4K Camera PCB Layout

Ver. 1/4/2021

010421_1100_TopPlacement.pdf

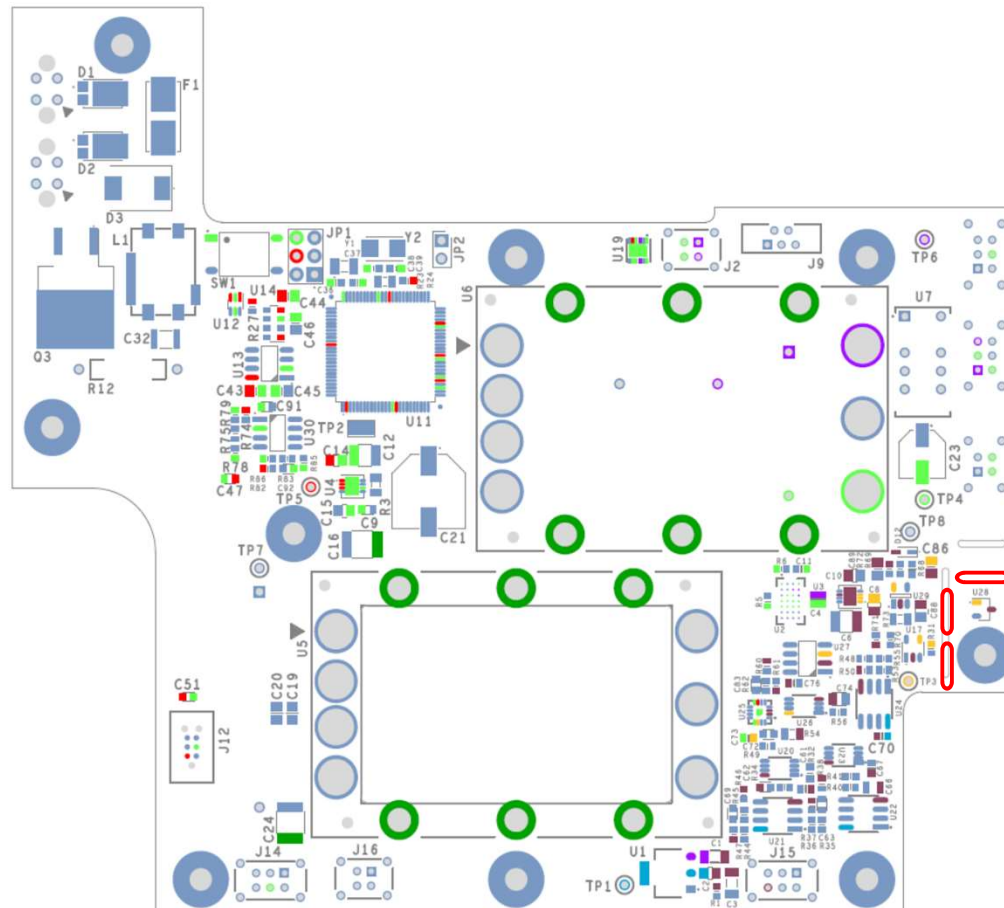
Modify cutouts!
Make closer to
stand-off & U28.
